**PROJECT NAME:: FACD08 RESTROOMS AT PREBLE TRUCK PARKING**  
**PROJECT No.: DOT-250005**

**ADDENDUM NUMBER ONE (1)**

February 27, 2026

OHIO DEPARTMENT OF TRANSPORTATION  
**FACD08 RESTROOMS AT PREBLE TRUCK PARKING**  
 170 WB @ MM 01, NEW PARIS, PREBLE COUNTY, OH 45347  
**MECHANICAL SCHEDULES**

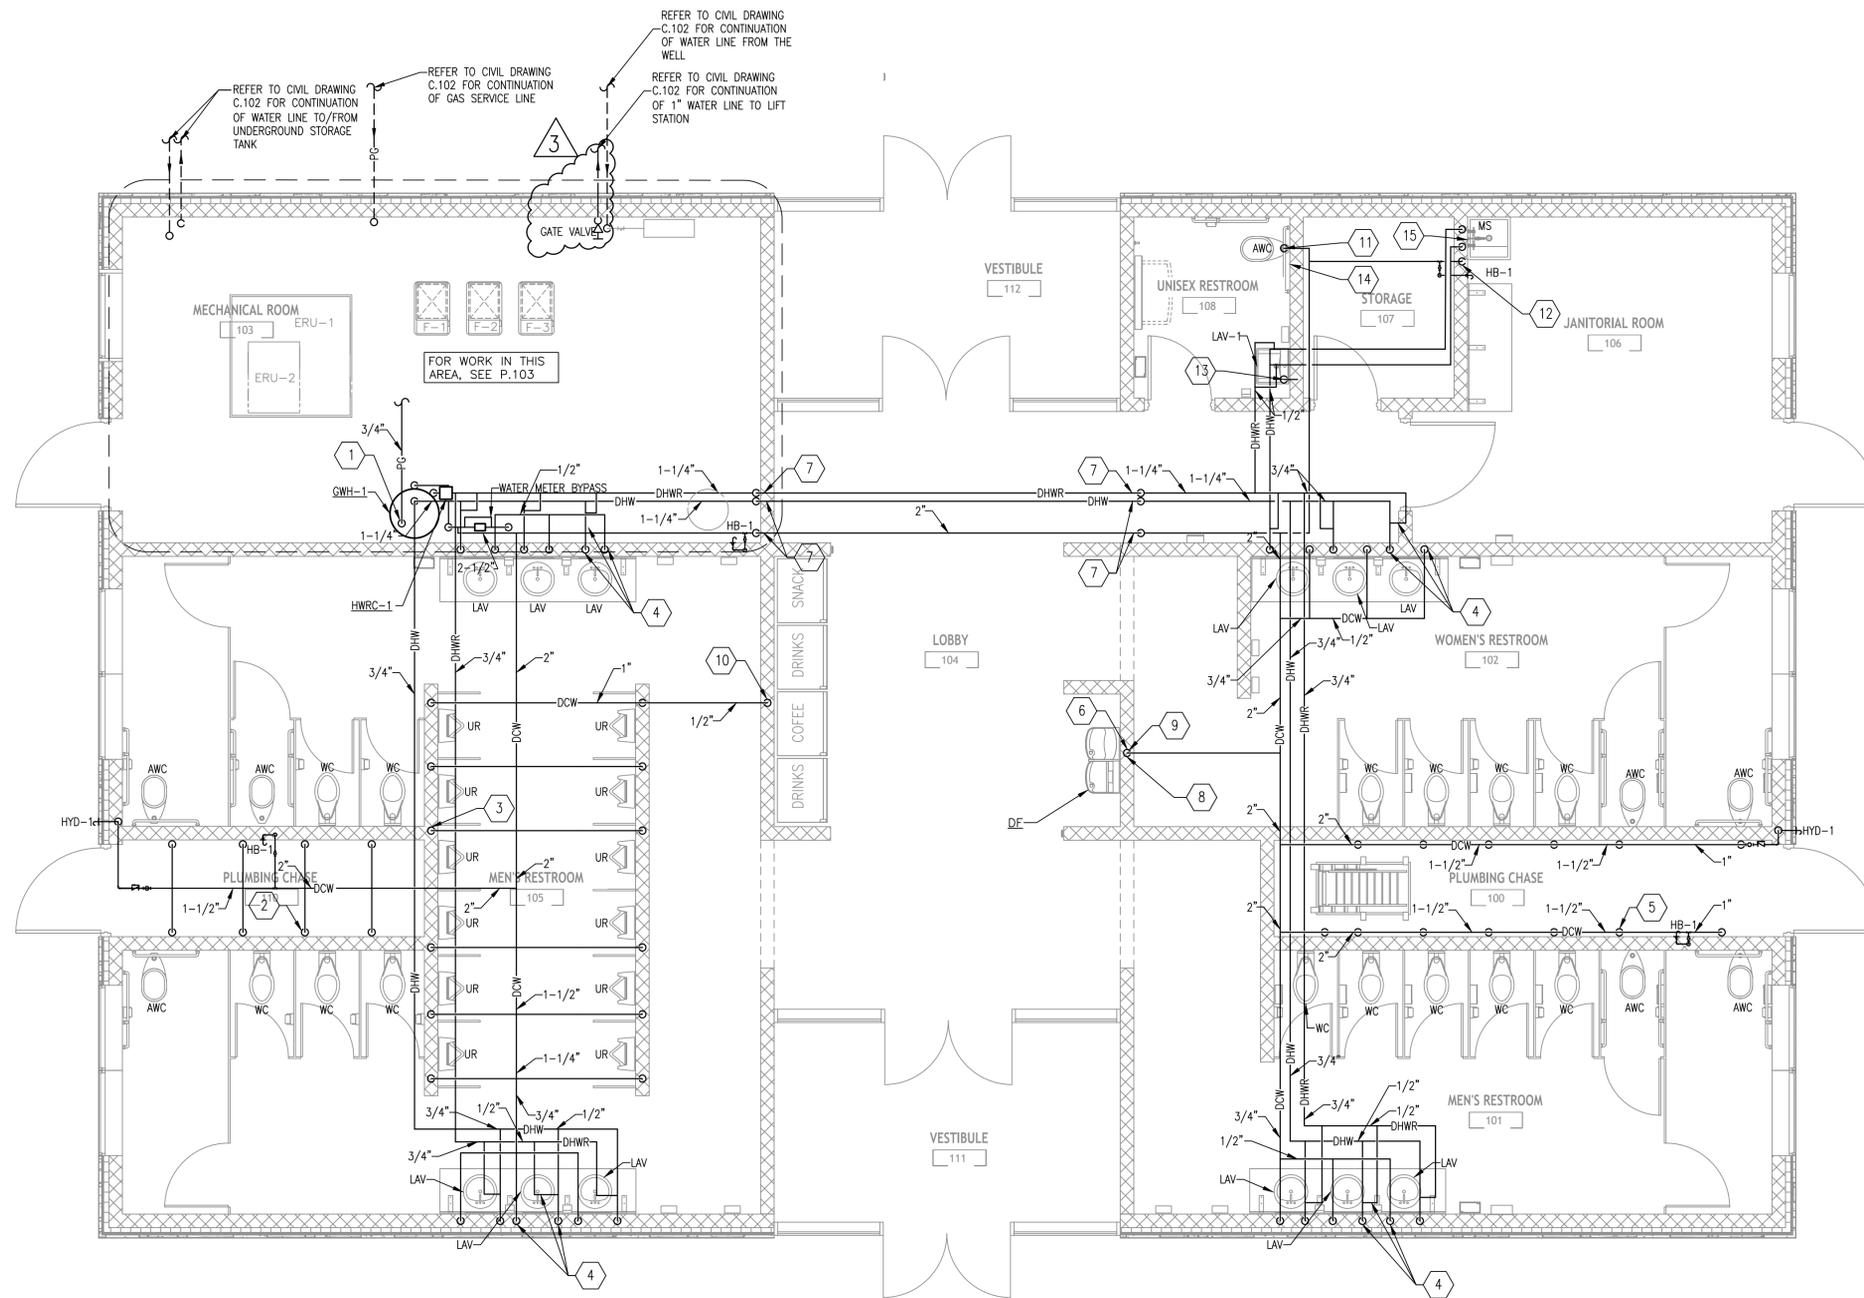
D-07. M.601 Revised air device schedule

**A UTILITIES PLUMBING PLAN**  
 1/4" = 1'-0"

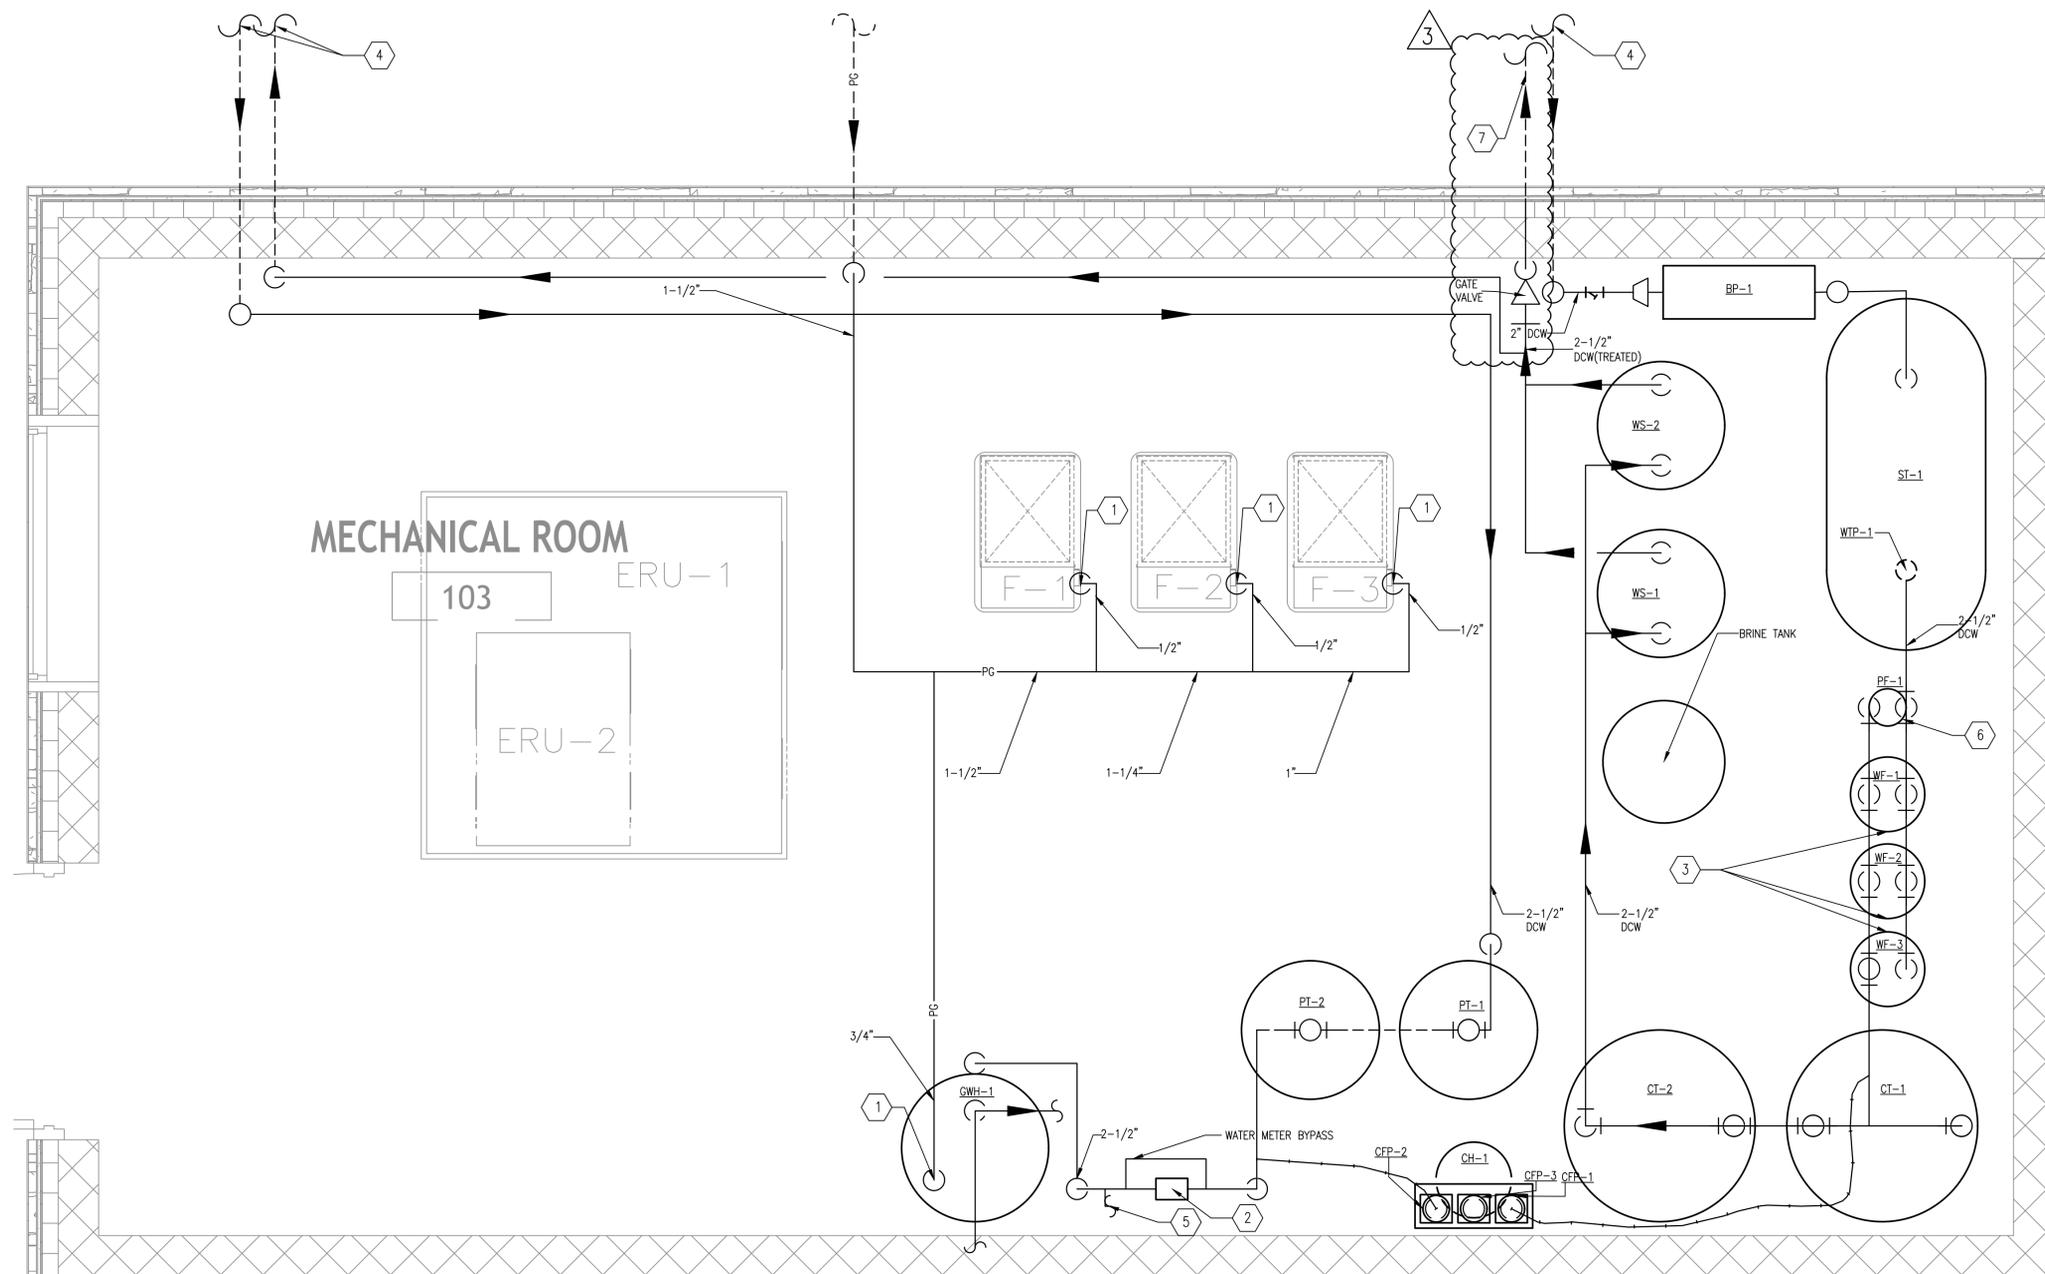
D-08. P.102, P.103 & P.501 Added 1" domestic cold-water branch with gate valve downstream of treated water system to serve Lift Station; drawings updated accordingly.
